#### Remarks

U.S. Patent Application Serial No. 09/775,370

[OPTIMIZED METAL ETCH PROCESS TO ENABLE THE USE OF]  
SEMICONDUCTOR DEVICE COMPRISING ALUMINUM-BASED PLUGS

FIG. 2D

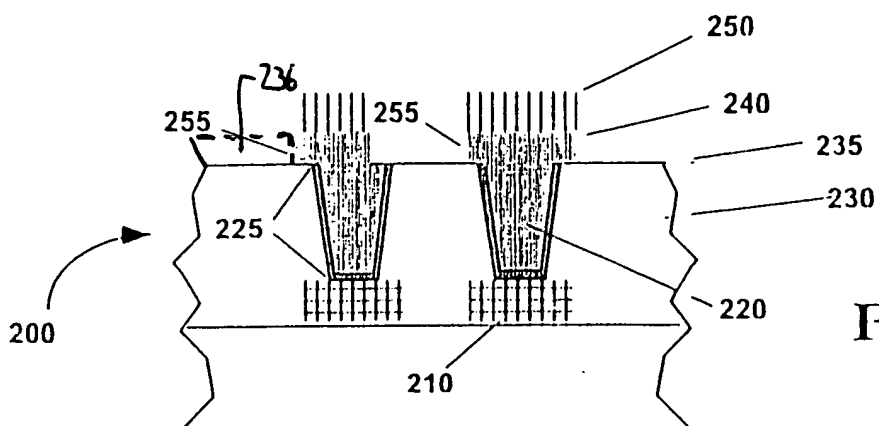
The Office Action dated February 27, 2002 indicated that the drawings stand objected to; the title is not descriptive; claims 28-32 and 34 stand rejected under 35 U.S.C. §112, first paragraph; claims 28-30, 34 and 36 stand rejected under 35 U.S.C. §112, second paragraph; and claims 27-37 stand rejected under 35 U.S.C. §103(a) as being unpatentable over *Korman* (U.S. Patent No. 5,959,357) in view of *Green et al.* (U.S. Patent No. 4,851,895).

Applicant respectfully submits that the drawing features recited as allegedly missing in the Office Action are shown, in the originally-filed drawings and/or as amended. For instance, referring to FIG. 2D and corresponding discussion on page 12, lines 4-14 of the Specification, a conductive structure (plug) 255 is shown having first and second upper surfaces and connects first and second metal portions 210 and 250. Furthermore, as one skilled in the art would recognize, the antireflective coating layer 250 may be removed wherein a metal portion, such as an interconnect or a contact, is formed in its place. Referring to FIGs. 2A-2D, a device layer 230

that may include a dielectric material is shown having an upper surface and, as the proposed drawing correction to FIG. 2D shows, may include a second upper surface at portion 236.

Referring to FIG. 2D, according to one embodiment of the present invention, to prevent recess formation in the non-overlapping portions of the via structures during the over etch process of the aluminum alloy metal lines, an example process 400 as outlined in FIG. 3 may be followed. In one particular implementation, the dielectric layer 230 includes a portion 236 having a second upper surface, wherein an upper surface of the conductive structures 255 are substantially-planar with the second upper surface of the dielectric layer 230.
